# UNITED STATES PATENT AND TRADEMARK OFFICE

APPLICATION NO.	FILING DATE	FIRST NAMED INVENTOR	ATTORNEY DOCKET NO.	CONFIRMATION NO.
10/501,908	07/20/2004	Shingo Matsui	108179-00040	8665

## Office Action Summary

## DETAILED ACTION

FIG. 5 (RELATED ART)

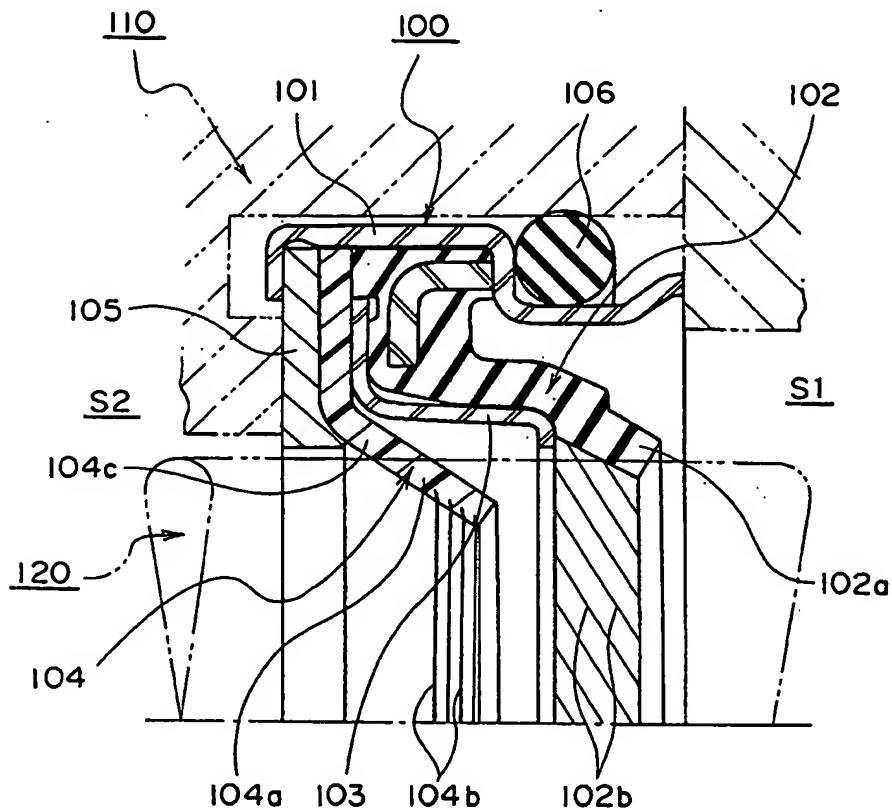
1. Figure 5 should be designated by a legend such as --Prior Art-- because only that which is old is illustrated. See MPEP § 608.02(g). Corrected drawings in compliance with 37 CFR 1.121(d) are required in reply to the Office action to avoid abandonment of the application. The replacement sheet(s) should be labeled "Replacement Sheet" in the page header (as per 37 CFR 1.121(d)) so as not to obstruct any portion of the drawing figures. If the changes are not accepted by the examiner, the applicant will be notified and informed of any required corrective action in the next Office action. The objection to the drawings will not be held in abeyance.

NOT APPROVED, VP 4/8/05
